Subject: Braidwood Nuclear Power Station, Units 1 and 2 Response to Request for Additional Information Regarding First 10-year ISI Facility Operating Licenses NPF-72 and NPF-77, NRC Docket Nos. 50-456 and 50-457

Attachment A

RELIEF REQUEST NR-25COMPONENT IDENTIFICATION

Pressurizer Seismic Lug and Restraint Detail

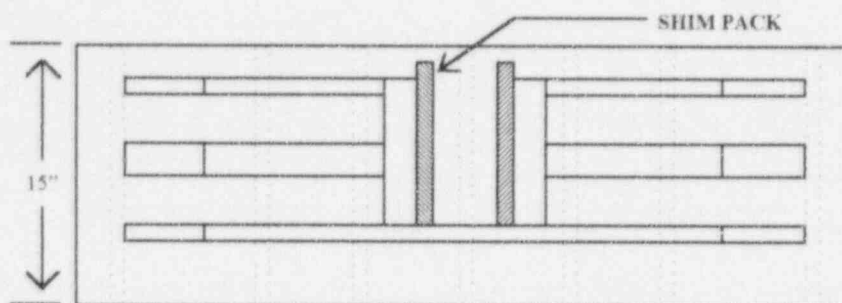
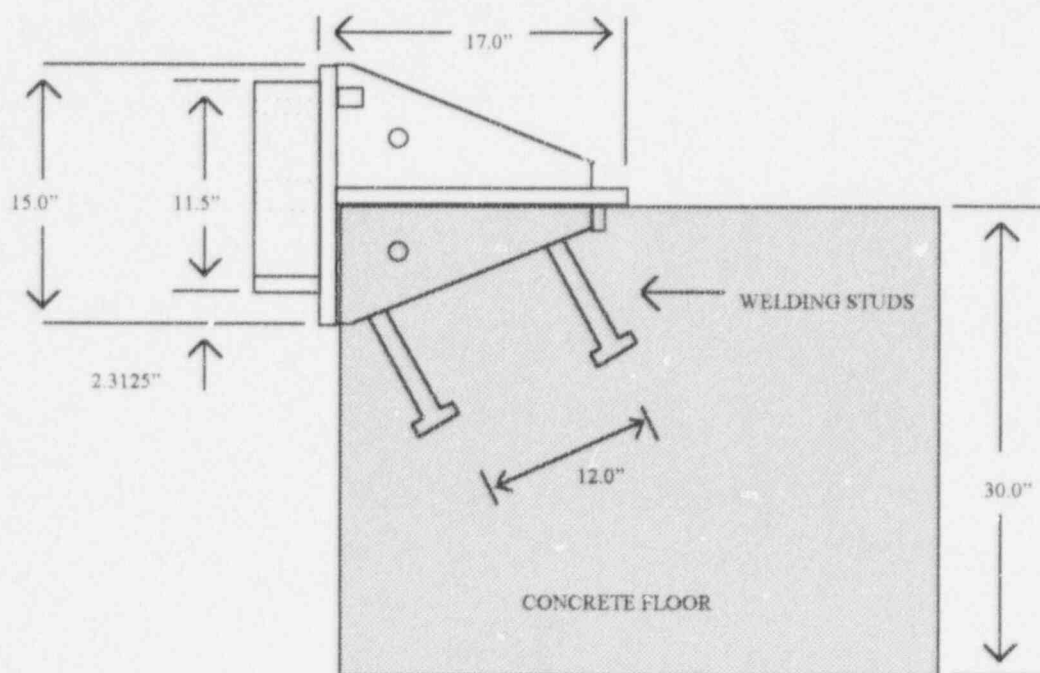
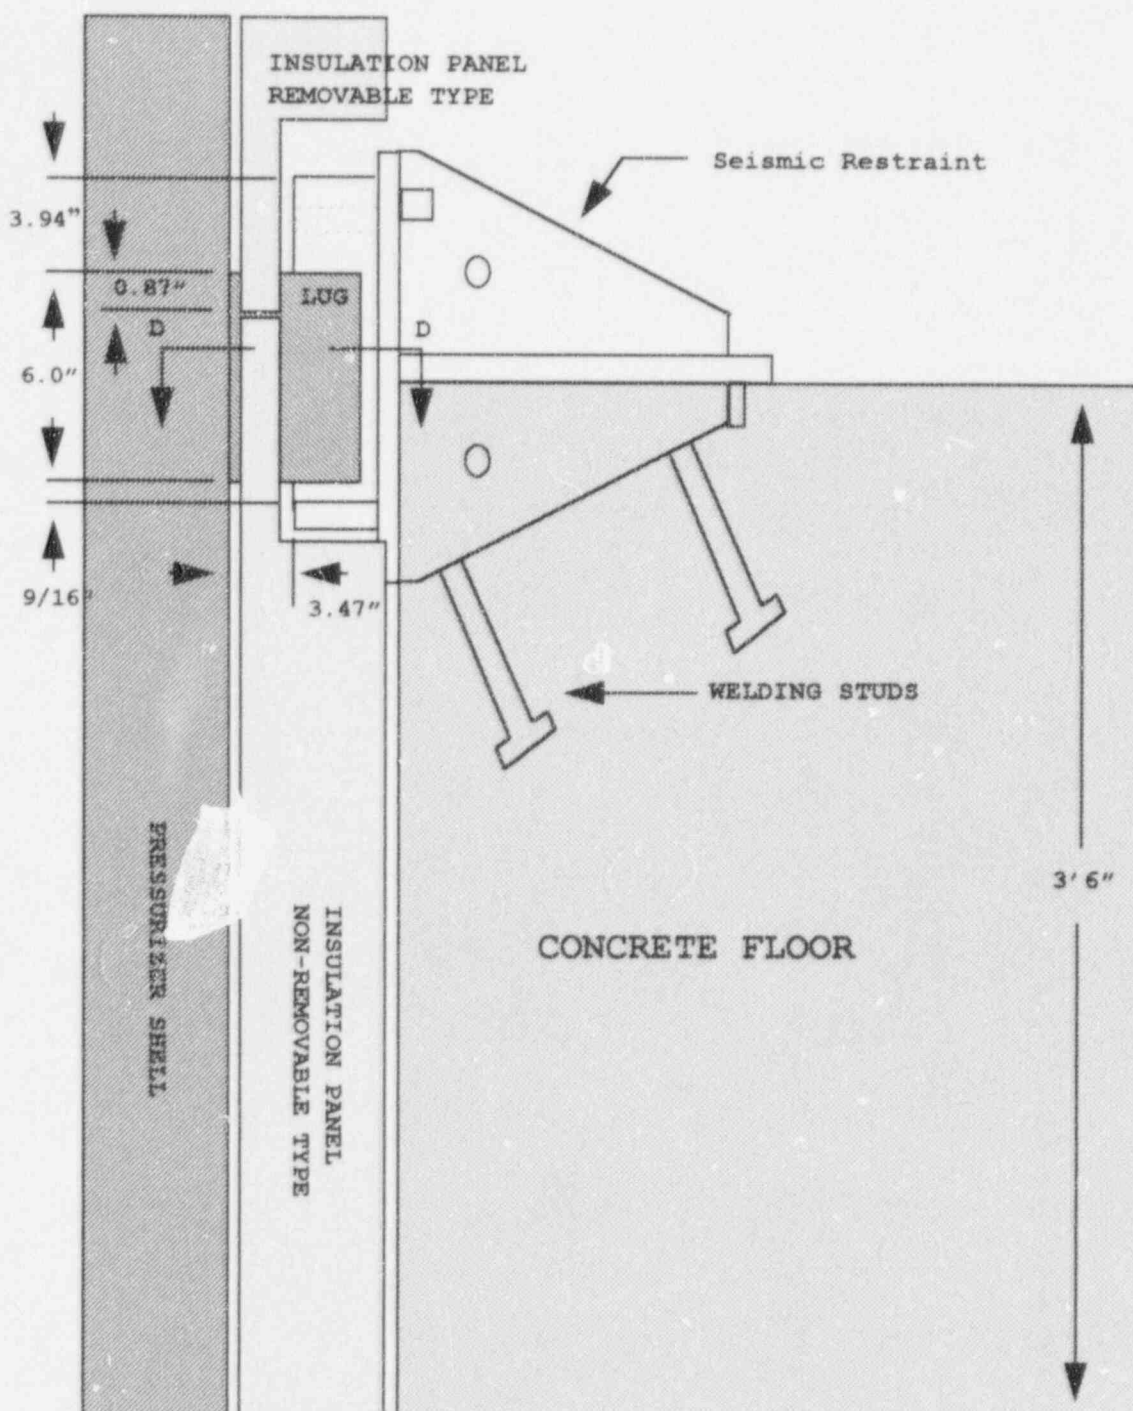
Braidwood Units 1 and 2 Pressurizer seismic lugs are welded to the Pressurizer shell (reference Attachment 1). There are 4 seismic lugs per unit, located 90 degrees apart (reference Attachment 5). In order to perform examinations on the seismic lug welds, the outside surface of the lower vessel shell to lug area must be accessible. The exam surface is not accessible since it is covered by the seismic lug restraint and lower Pressurizer shell insulation (reference Attachment 3 and 4). Also, the configuration of the Pressurizer coffin limits access to the seismic lugs. The impact of removing the seismic lug restraint, altering the Pressurizer coffin and removing the lower shell insulation is presented below.

The seismic restraint (Reference Attachment 1 and 2), which surrounds the lug, prohibits access needed to perform a meaningful surface exam. There are 4 restraints located about the 428' elevation, one for each lug, which were not designed for removal. The top of the concrete floor at this location is at 428' 3" elevation. This floor, which is 2'6" thick, interferes with access to 2 of the 4 lugs (Reference Attachment 2, 3 and 5). Also, the Pressurizer coffin itself severely limits access to remaining 2 seismic restraints (Reference Attachment 5). All of the restraints, which are embedded in the concrete, would require major modification to the existing Pressurizer coffin to allow for removal and access. This modification would require the redesign of the seismic restraint and Pressurizer coffin to allow for periodic removal and access to the seismic restraints. Implementation of this redesign would require significant engineering resources, construction resources and significant dose to plant personnel.

A VT-1 of the upper surfaces of the 2 accessible lugs when the removable insulation panels are removed. It is estimated that 5.74" per accessible lug (4" of the top and .87" of each side) will be achievable when the removable insulation panels are removed. This is approximately 1.5% of the total exam volume for one lug. Also, a best effort surface inspection (Liquid Penetrant) will be performed on those portion of the lug that are inspectable when the removable insulation panels are removed. In conjunction with the above proposed alternative technique, the periodic VT-2 examinations in accordance with the requirements of ASME Section XI, Table IWB-2500-1, Examination Category B-P and applicable Reactor Coolant system monitoring requirements specified in the Technical Specifications will provide reasonable assurance of continued structural integrity of the Pressurizer shell.

Pressurizer Seismic Lug and Restraint Insulation Detail

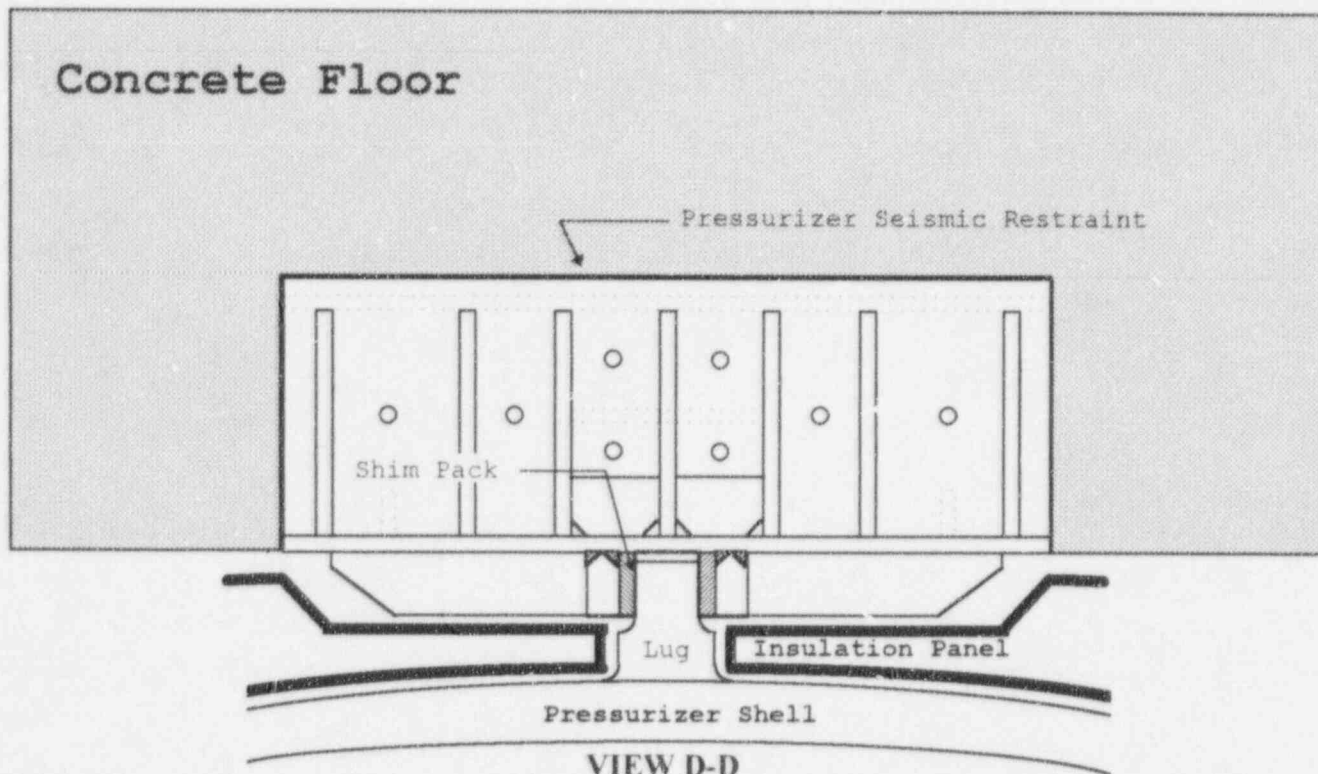
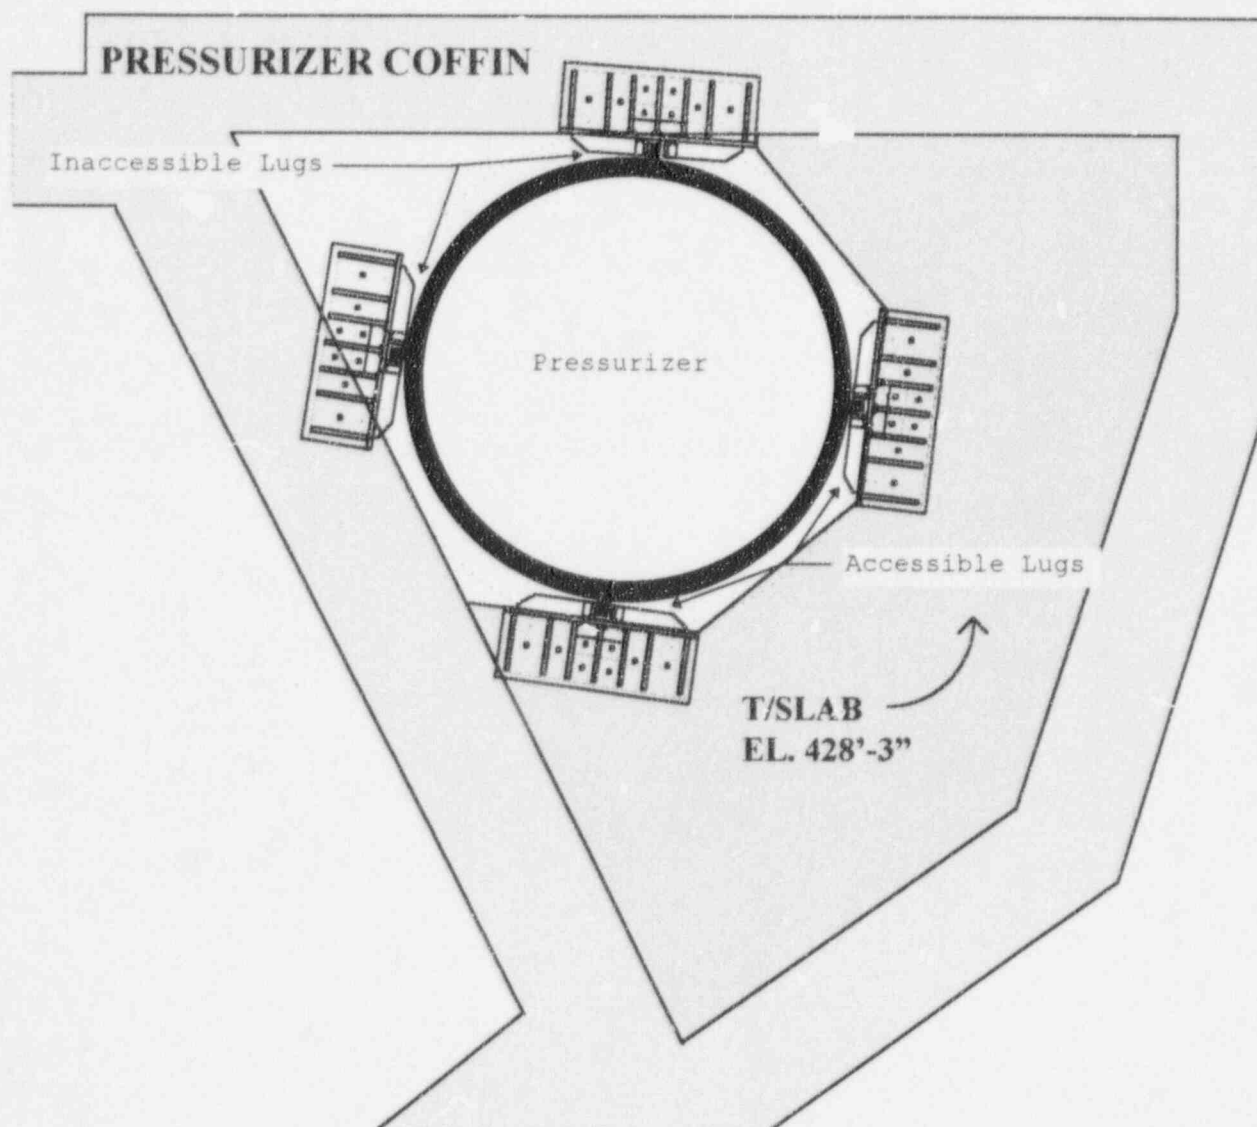
Only the upper panels were designed with clips to provide for removal. Insulation on the lower shell of the Pressurizer prohibits access needed to perform a meaningful surface examination of the seismic lug weld areas. The removal of the insulation covering the lower Pressurizer shell to seismic lug area will result in high radiation exposure to plant personnel. The insulation on the pressurizer consists of panels which are fastened together. The lower panels are fastened together with screws. To provide access from below would require scaffolding from the 401' elevation grating to the 428' elevation of the seismic restraint. Also, to remove the Pressurizer shell insulation would require removal of the screw fasteners. Access to these screws is limited by the floor and Pressurizer coffin (reference Attachment 4 and 5). As stated above, the insulation could be removed from the upper portions of the lugs. This can only be accomplished for 2 of the 4 seismic lugs, because access is prohibited by the Pressurizer coffin configuration (Reference Attachment 5). The current configuration of the seismic restraint also only allows limited access for visual examination. To provide suitable access for all 4 seismic lug restraints would require major modifications and significant resources.

Even if the non removable insulation is removed (Reference Attachment 3, 4 & 5), full surface examination of the seismic lugs would not be achieved. The Pressurizer coffin, concrete floor and seismic restraint geometry would greatly limit access to all sides. The resulting coverage would only be a small percentage of the weld volume. The limited data obtained from these examinations do not provide a compensatory increase in quality and safety to justify the hazards of personnel radiation exposure to obtain the data. When the removable insulation panels are removed, it is estimated that 5.74" of surface per accessible lug will be achievable. This accessible portion of surface can be visually inspected. It is expected that only a best effort Liquid Penetrant (PT) exam can be performed on the accessible exposed surfaces. Access and clearance interferences will limit how well the surface of the examination volume can be prepped for the PT examination. Because the examination is being performed on slightly rusted carbon steel components, which will receive a best effort surface prep, that a white to pinkish back ground will be expected after developing. Even with a pinkish background, detection of relevant indications will still be possible. Also, bleed out from the lower edge of the non removable insulation will interfere with some of the accessible exam volume. This volume of interference will depend upon the amount of bleed out and will mask any relevant indication.

TYPICAL TYPE 2 PENETRATIONTYPICAL TYPE 3 PENETRATION

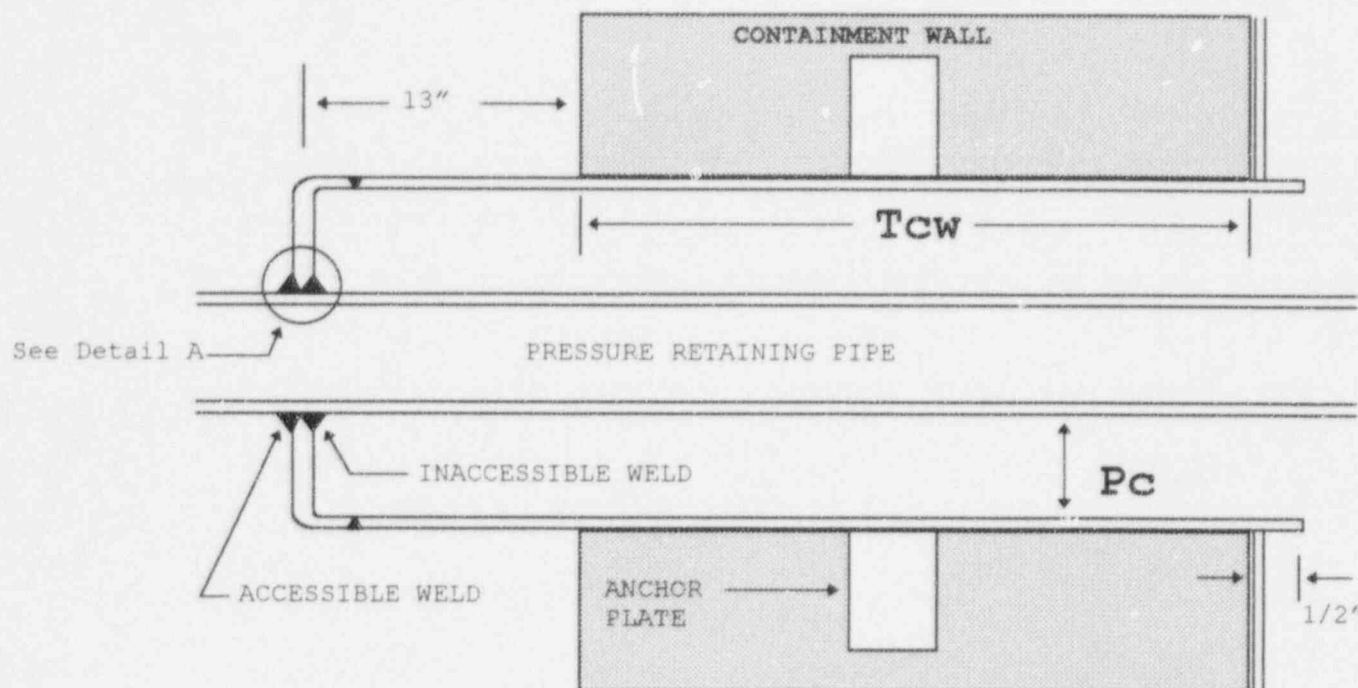
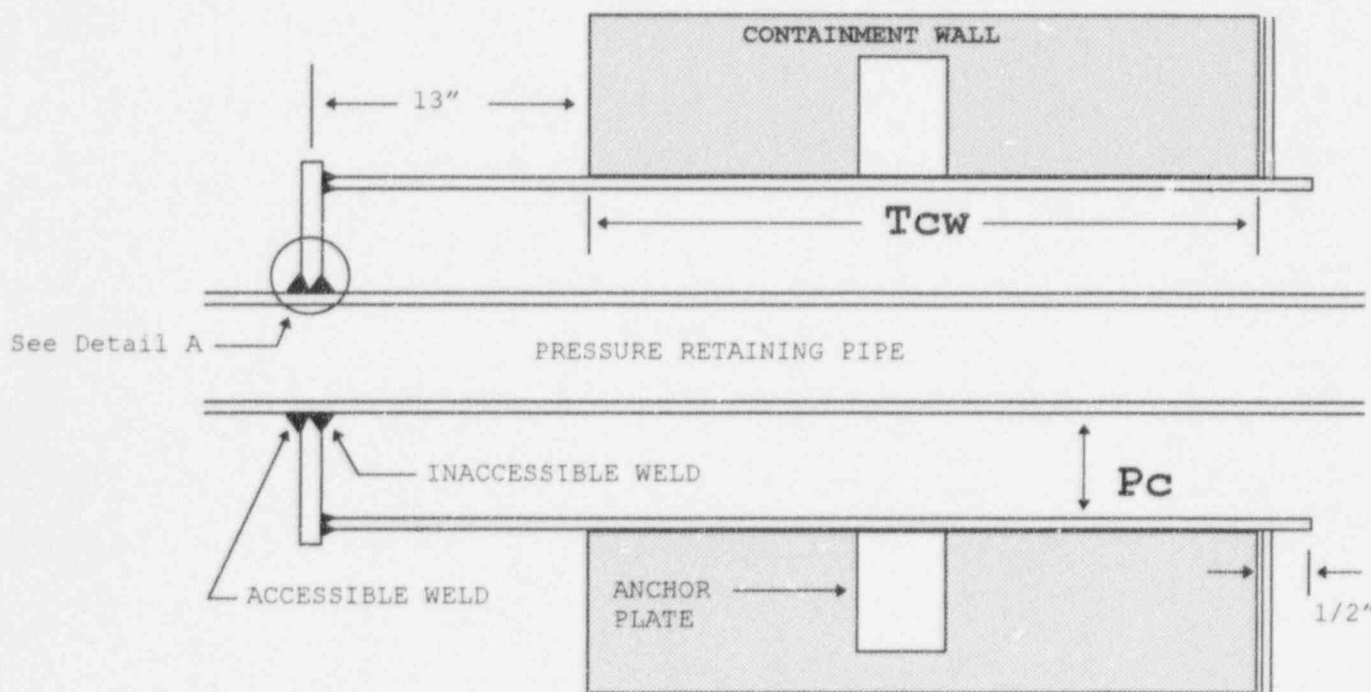
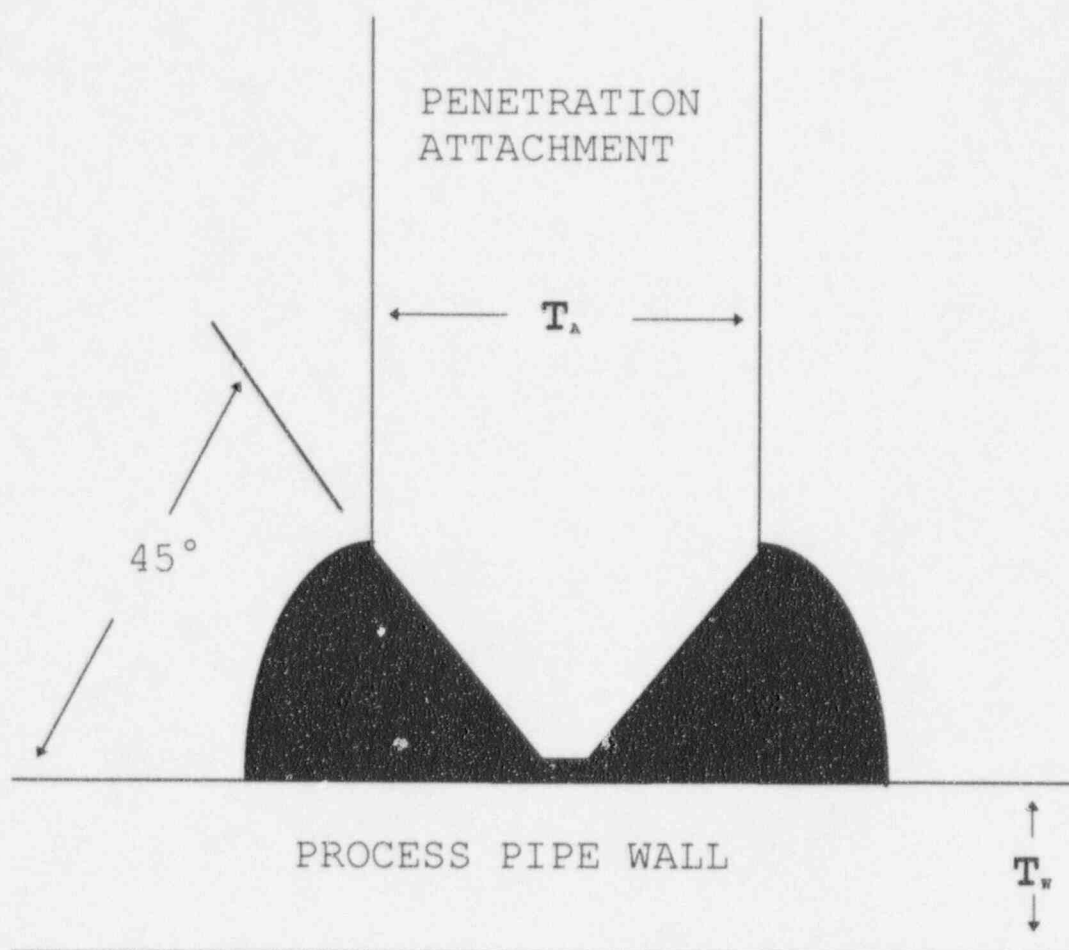
Some penetrations at Braidwood were originally designed where one of the integral attachment welds is inside the flued head penetration assembly, thus making the welds inaccessible for inservice inspection. Access from outside of the closed end of the flued head penetration assembly for examiners is prohibited by the integral attachment. Access from the open end of the penetration is severely restrained due to geometry and clearance. See Attachments 1, 2, 3, 4 and 5 for penetration details. The integral attachment weld is set back some distance inside the flued head penetration assembly and the clearance between the pipe and penetration sleeve is small. See Table 1 on Attachment 6.

To satisfy the Code requirement to perform a surface examination of this weld, modification to the flued head penetration assembly and/or piping to allow access would be required. Braidwood would incur significant engineering and installation costs to perform such a modification without a compensating increase in the level of quality and safety to justify such modifications.

When a weld is scheduled for inspection, a surface examination of the accessible weld on the exposed outside surface of the penetration will be performed. In conjunction with the above proposed alternative technique, the periodic VT-2 examinations in accordance with the requirements of ASME Section XI, Table IWC-2500-1, Examination Category C-H will provide reasonable assurance of continued structural integrity of the piping systems.
